Re: St. Lucie Plant Unit 1  
Docket No. 50-335  
Renewed Facility Operating License No. DPR-67

Response to NRC Instrumentation & Controls Branch Request for Additional Information Regarding Extended Power Uprate License Amendment Request

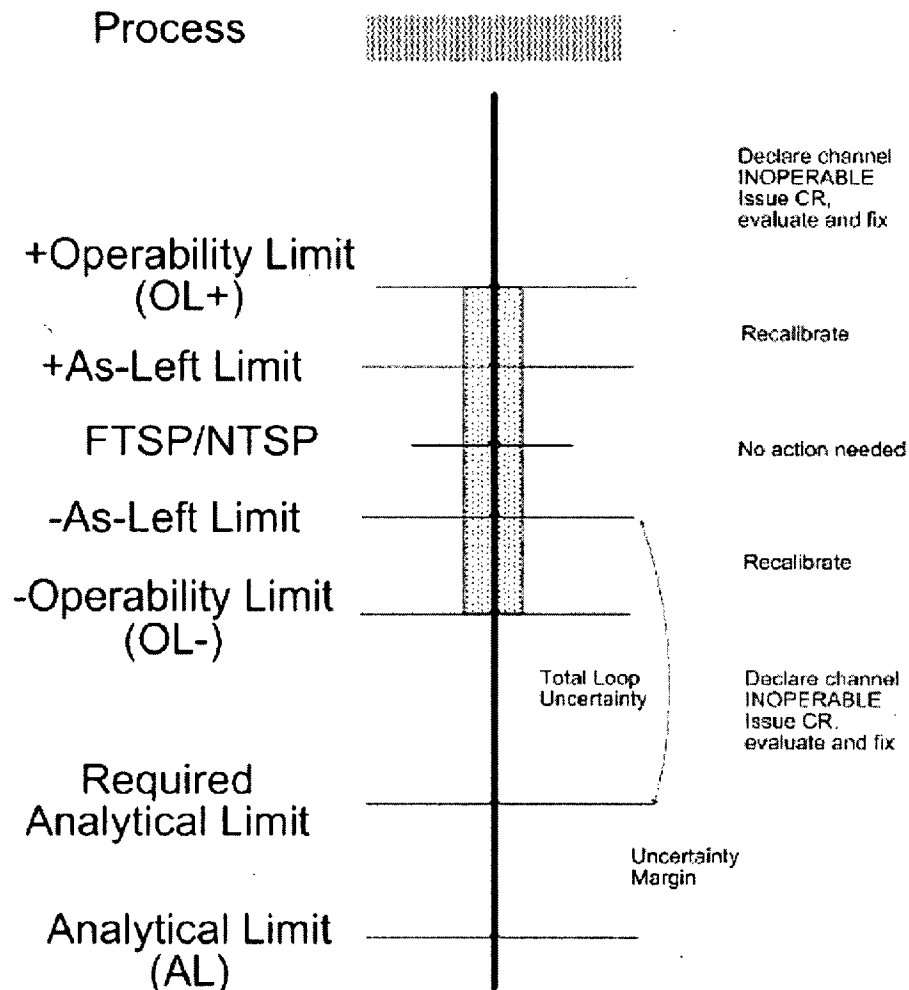
The summary of the calculation provided does not contain all the information needed by Staff to complete the review. The licensee is requested to provide the Staff with a copy of the calculation since this is the only calculation that involves setpoint change. The calculation should clearly state the as-found tolerance, as-left tolerance, the allowable value and the NTSP or the FTSP.

The requested Steam Generator Level setpoint calculation is identified as CN-TAS-08-36, Revision 1, "Setpoint Uncertainties and Operability Limits for the Steam Generator Level RPS and AFAS Functions for St. Lucie Unit 1". This calculation is a Westinghouse proprietary document and will be made available for NRC review. As documented in the Technical Specification markups of Attachment 3 of the EPU License Amendment Request (NRC Accession Number ML103560427), the proposed RPS Low Steam Generator Level TS trip setpoint is  $\geq 35.0\%$  and the Allowable Value is  $34.78\%$ , which is equal to the low side of the Operability Limit band. OL limits (synonymous with AFT), as-left tolerance and FTSP are defined in the setpoint calculation and illustrated in the following figure that has been extracted from the setpoint calculation.
